PROJECT NAME Northern Bank Town Common Peer Review

Peer Review Comment Form

Northern Bank Proposal FBC Review

Comment #5: Building B has a prohibited building component

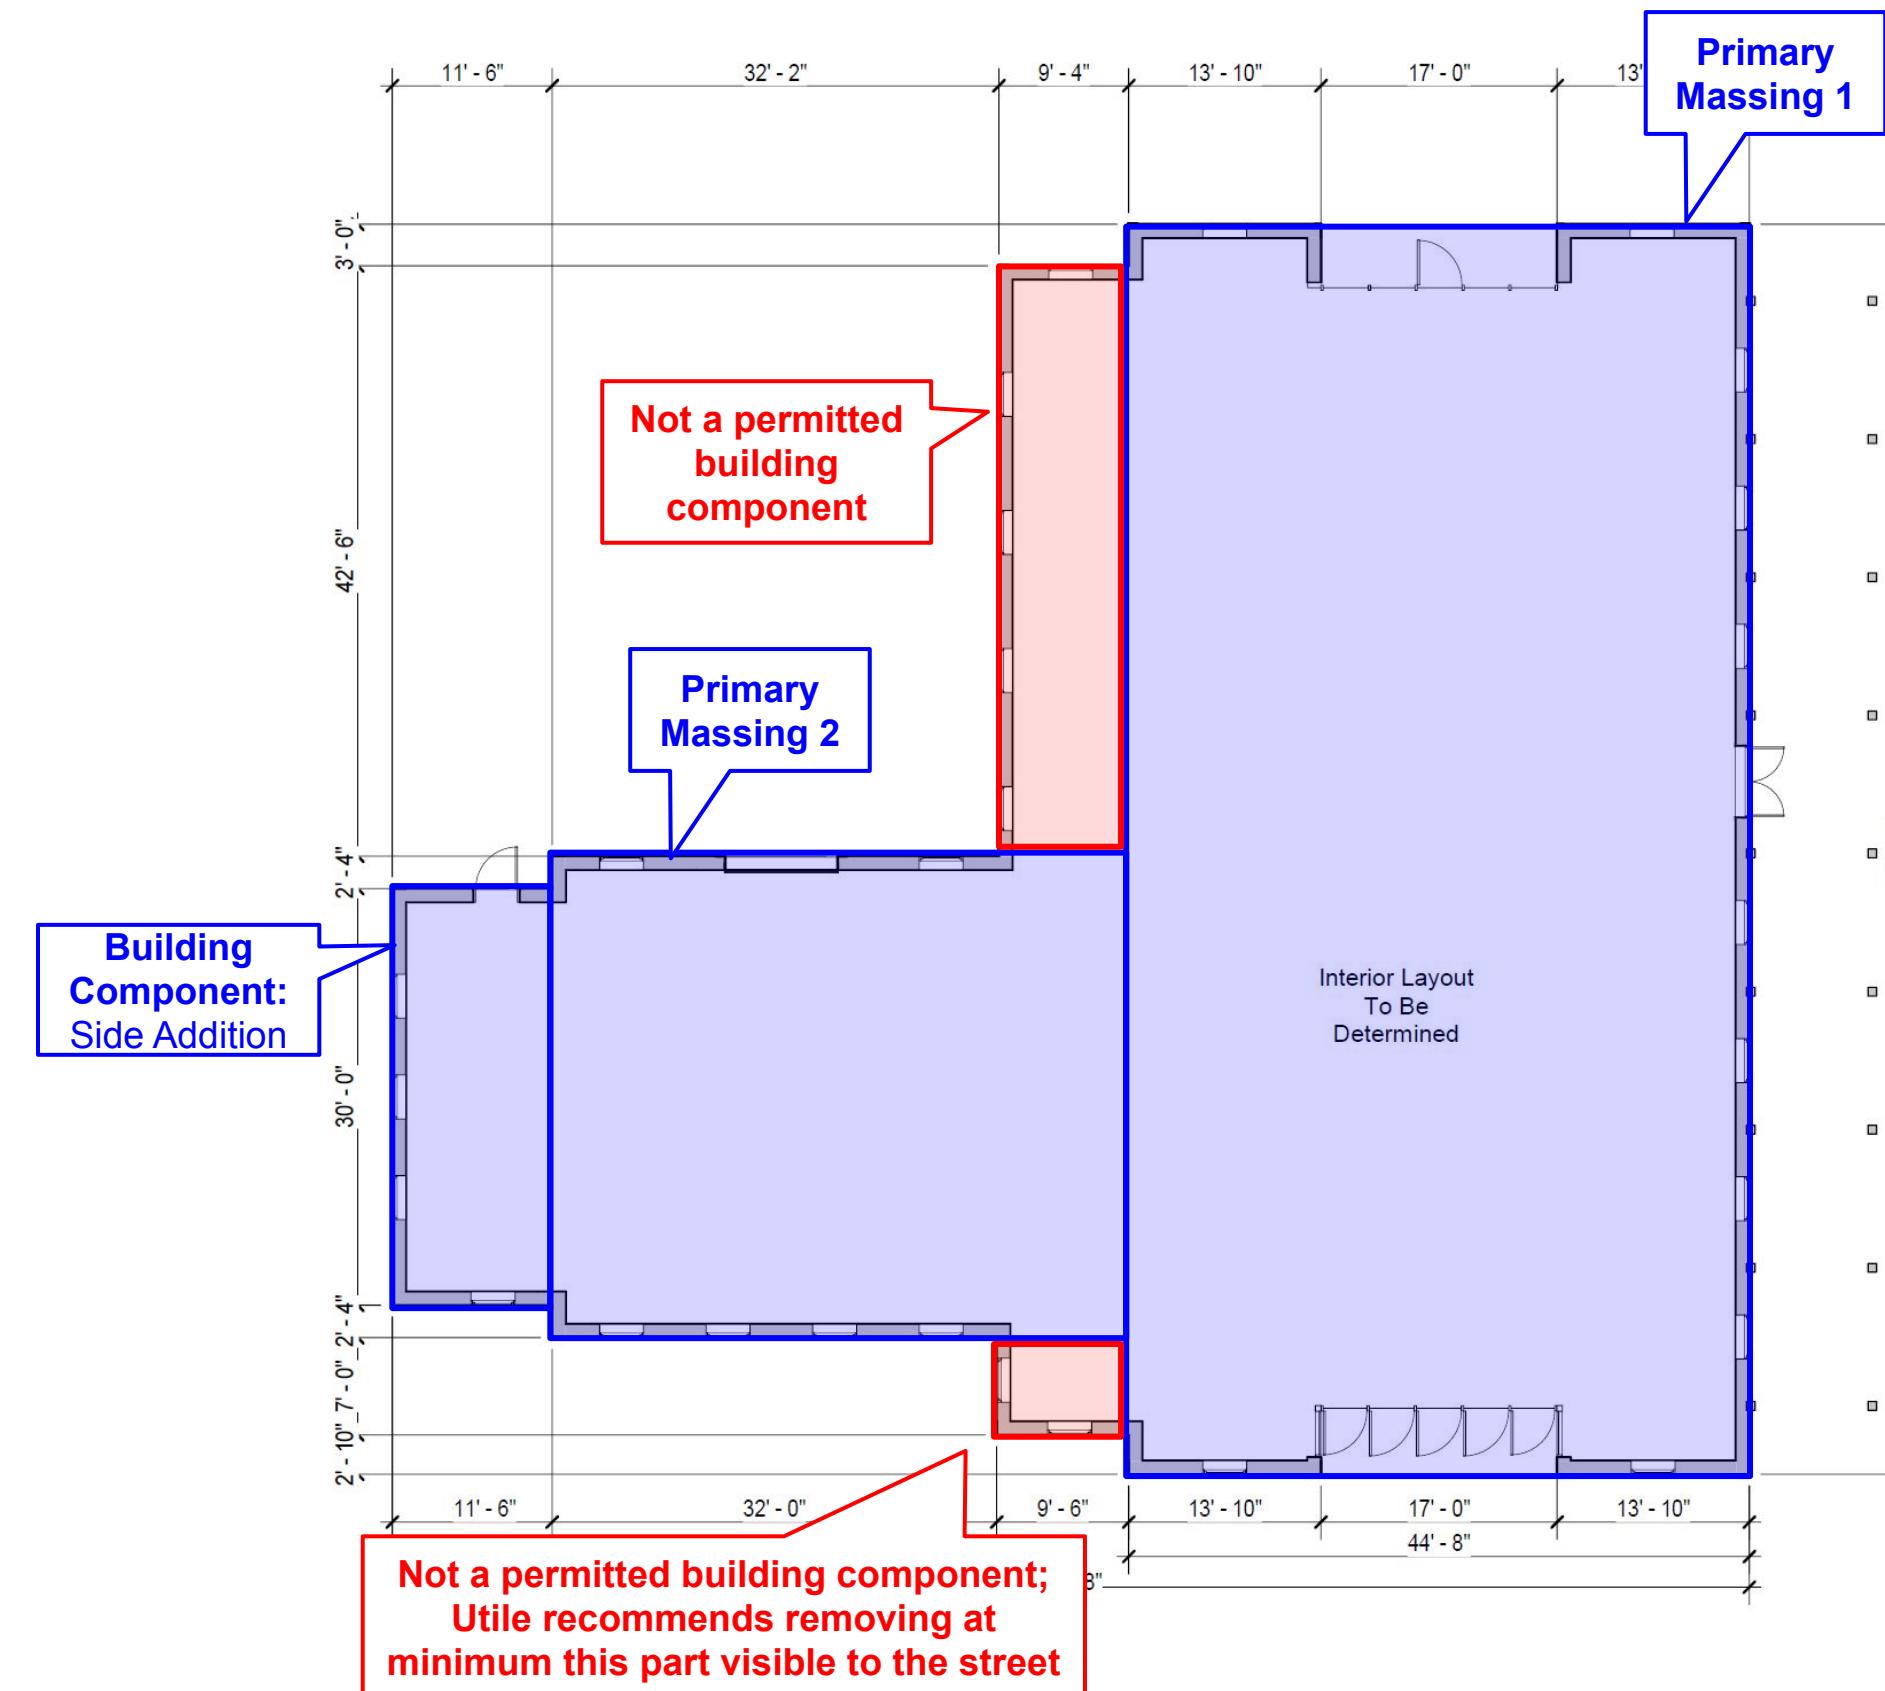
Comment #5	
Sheet No.	Building B - Floor Plan (Page 6 of "N Bank Architectural Updated 11-14-2022.PDF")
FBC Section	Building Standards §173-221.B.a.
FBC Text	<i>"Buildings are comprised of one or more primary massings and various optional building components that are assembled to make a single building complex."</i>
Utile Comment	While labels are missing on the floorplan, this building appears to be comprised of 1 larger primary massing with its narrow end oriented toward the front lot line, one smaller primary massing with its long side oriented toward the front lot line, and one side addition appended to the end of the smaller primary massing. However, there is a 1-story ~9'-4" narrow strip at the middle that is neither a primary massing nor a permitted building component.
Utile Recommendation	Utile recommends removing, at minimum, the portion of this strip that is visible from the street and consequently preserving a simple farmhouse-like reading of 2 intersecting primary massings along Great Rd.

Comment #8: Building B building component has inadequate setback

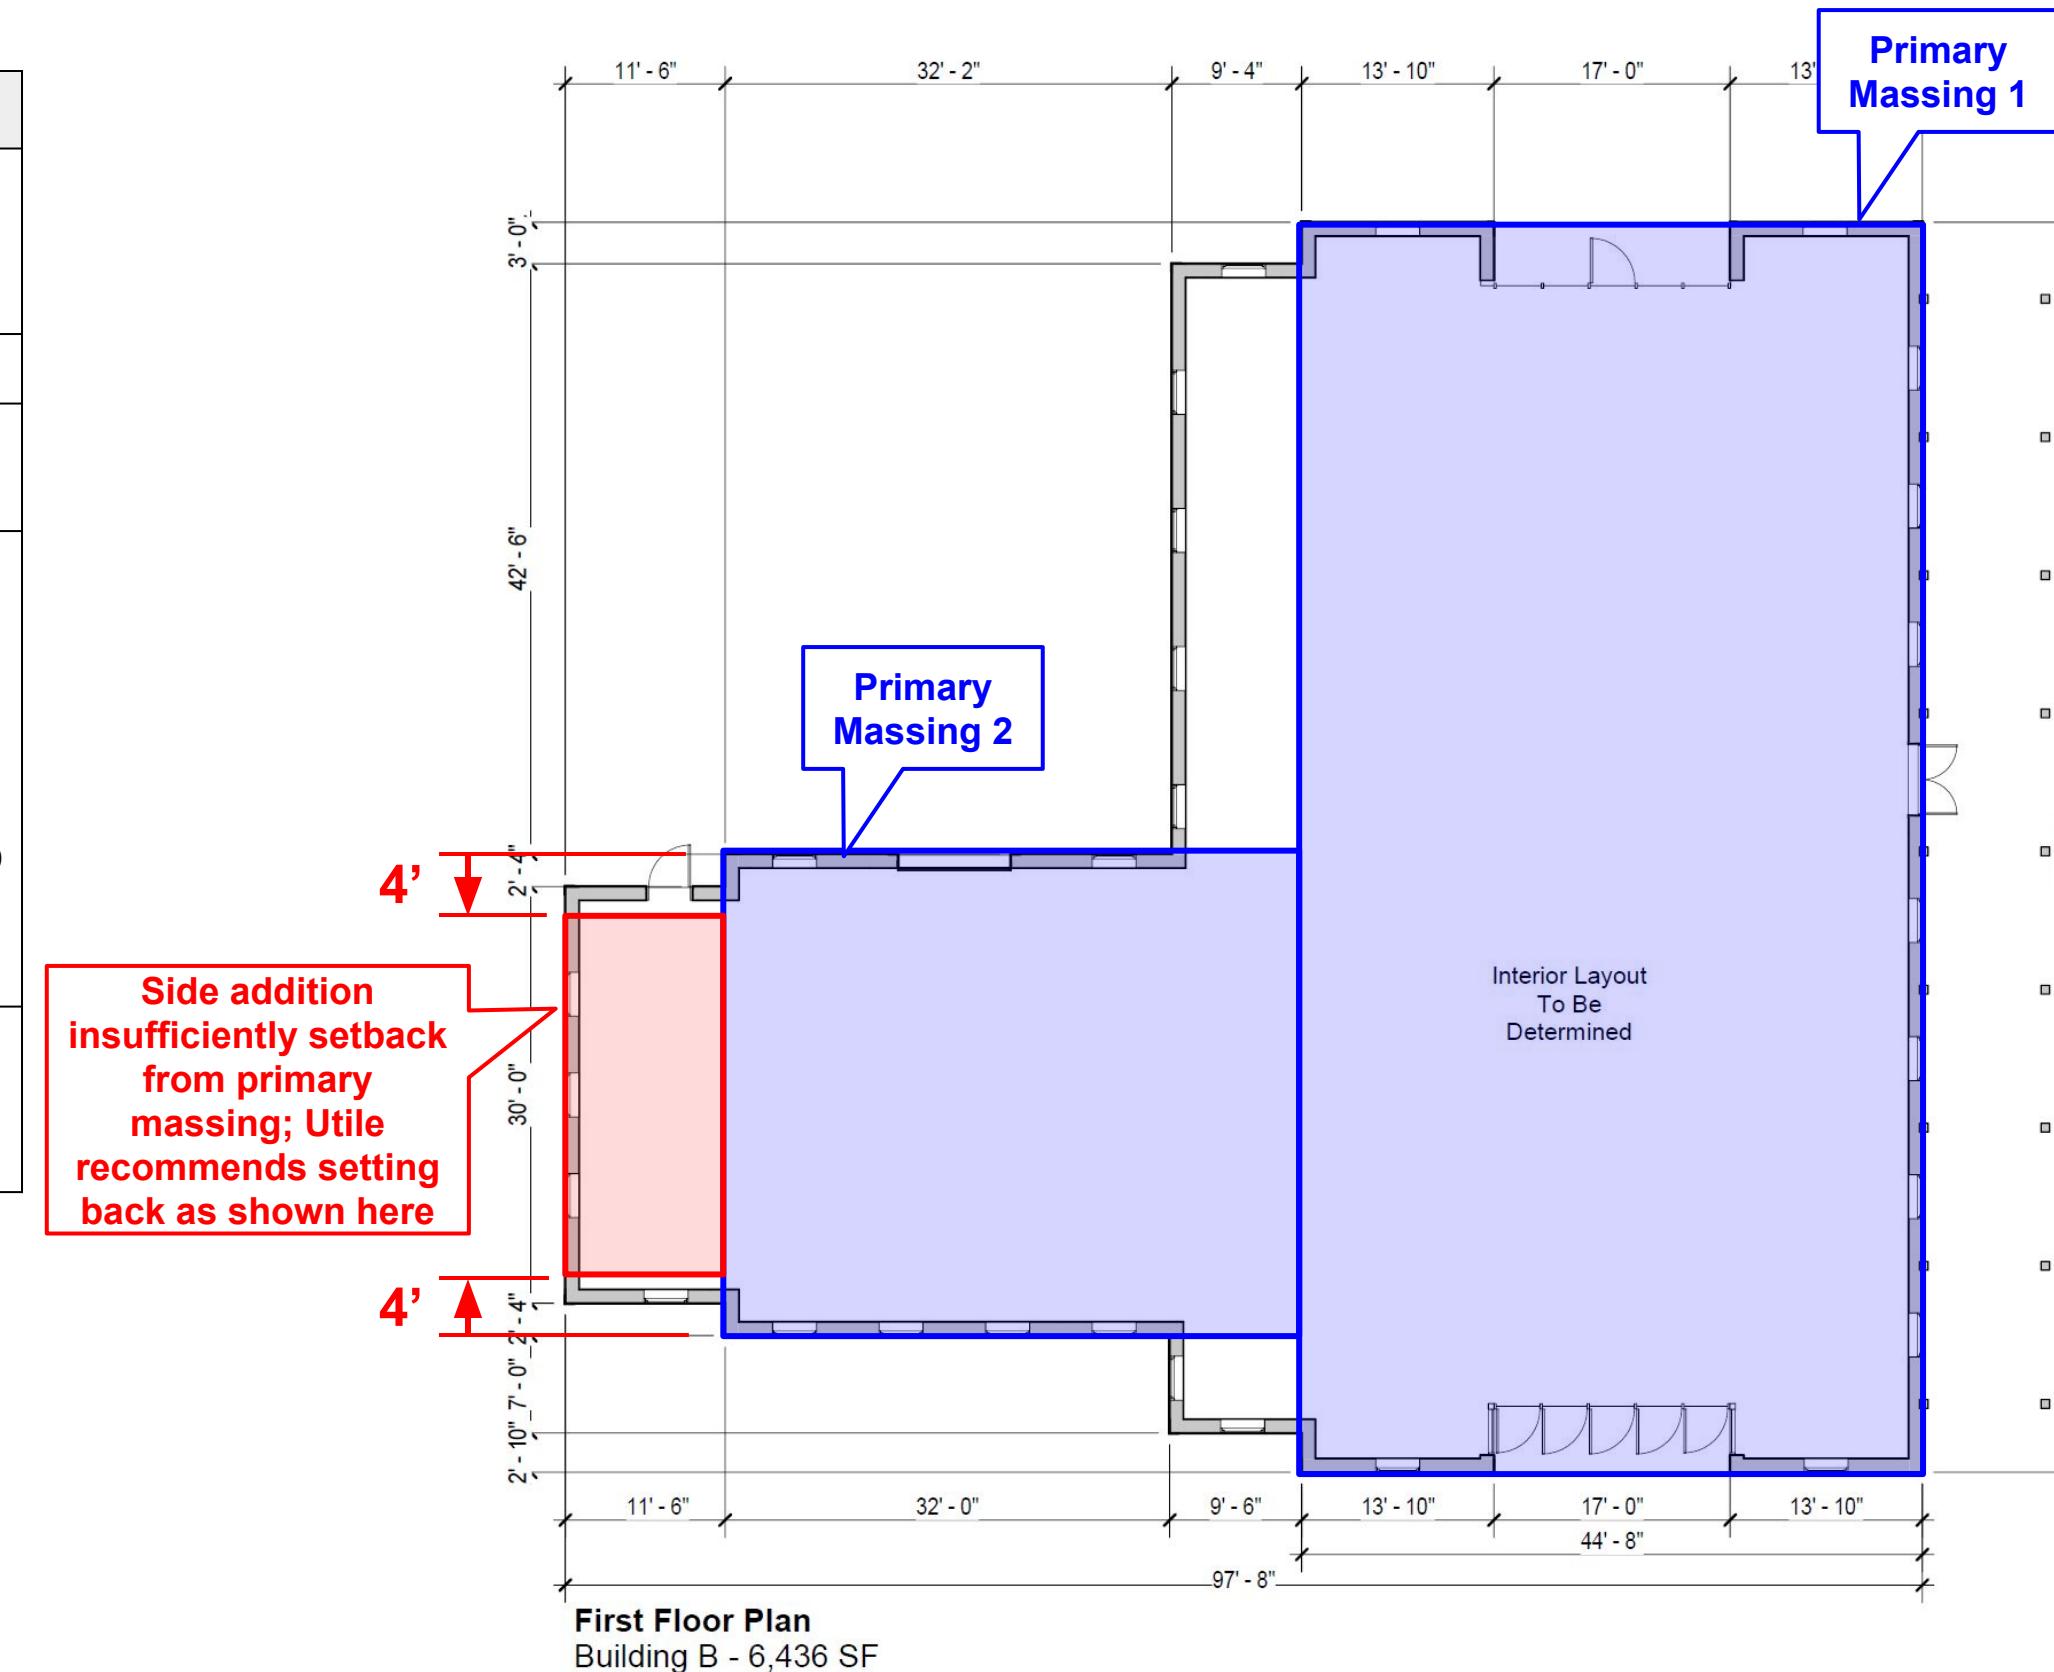
Comment #6	
Sheet No.	Building B - Elevations (Page 4 of "N Bank Architectural Updated 11-14-2022.PDF")
FBC Section	Building Standards §173-221.G.b.
FBC Text	<i>"For buildings with ground story commercial spaces, ground story fenestration is measured between two (2) feet and twelve (12) feet above the finished floor of the ground story."</i>
Utile Comment	The façade of Building B does not meet the minimum fenestration percent (~33% out of the minimum 60%). The proponent suggests including the full height of the entrance storefront into the calculation of the fenestration percent, which would more or less meet the minimum percent.
Utile Recommendation	Utile deems this an acceptable deviation and defers to the Town's discretion.

Comment #7	
Sheet No.	Building B - Floor Plan (Page 6 of "N Bank Architectural Updated 11-14-2022.PDF")
FBC Section	Building Standards §173-221.J.b.i.
FBC Text	<i>"Each primary massing must have at least one (1) principal entrance. The principal entrance of a building must be located on the façade for any building contributing toward the frontage build out calculation."</i>
Utile Comment	The smaller of the 2 primary massings of this building (with its long side oriented toward the front lot line) does not have a principal entrance. Principal entrances on the facades of primary massings make ground floor commercial uses approachable and activate the public sidewalk.
Utile Recommendation	Utile recommends adding a principal entrance on the facade of this primary massing (with attendant footpaths, etc.).

Comment #8	
Sheet No.	Building B - Floor Plan (Page 6 of "N Bank Architectural Updated 11-14-2022.PDF")
FBC Section	Building Standards §173-221.L.a.
FBC Text	<i>"Building components are...permitted according to the following schedule."</i>
Utile Comment	The side addition attached to the narrow end of the smaller primary massing does not meet the minimum setbacks from the façade and rear wall (currently showing 2'-4" out of the required 4'-0"). Setbacks for side and rear additions are intended to further reduce the scale of building assemblies.
Utile Recommendation	Utile recommends increasing both setbacks to meet the minimum 4'-0".

Comment #9: Building C primary massing exceeds maximum width

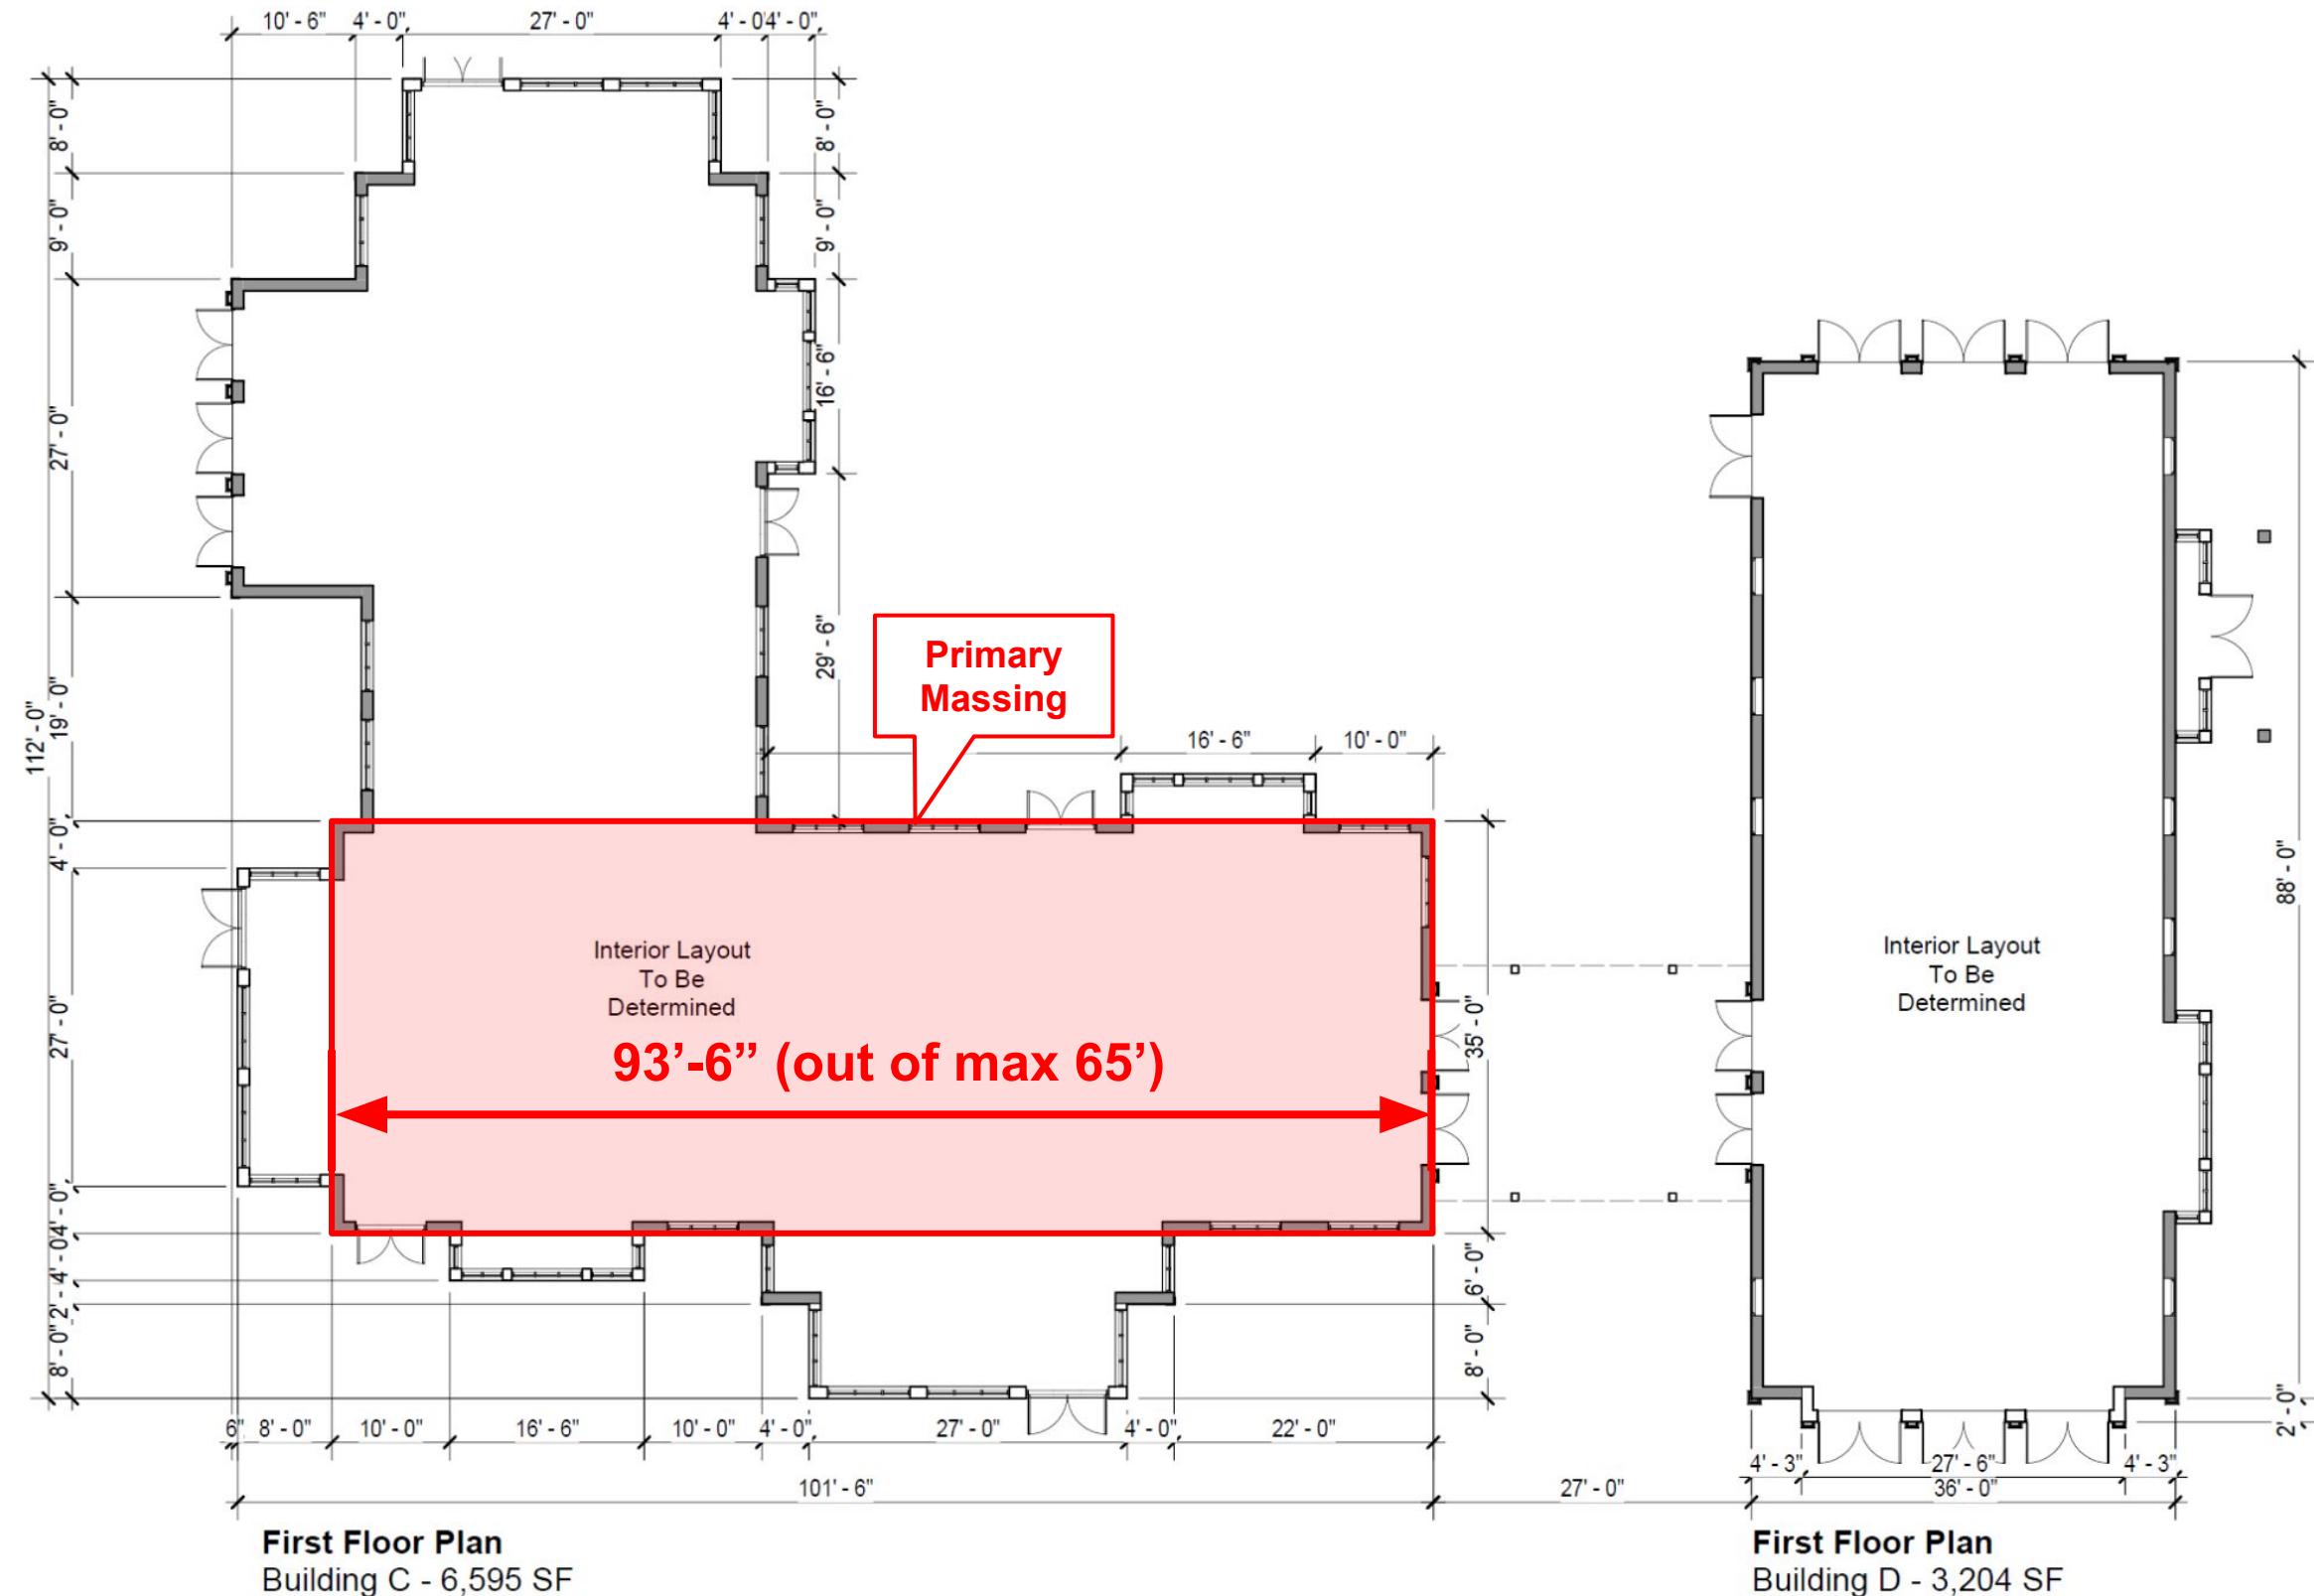
Comment #9	
Sheet No.	Building C & D - Floor Plan (Page 11 of "N Bank Architectural Updated 11-14-2022.PDF")
FBC Section	Building Standards §173-221.K.
FBC Text	The FBC table for Building Standards indicates that the maximum width of a primary massing with its long side oriented toward the front lot line is 65 ft.
Utile Comment	The width of the primary massing shown is 93'-6", exceeding the maximum of 65 ft. The maximum widths of primary massings with its long side oriented front is intended to reduce the perceived scale of buildings from the public realm.
Utile Recommendation	Utile recommends splitting this single primary massing into 2 primary massings that are offset from each other by the minimum required 8 ft, or alternatively, making the long, deep part of the building a primary massing and the side as another intersecting primary massing, etc.
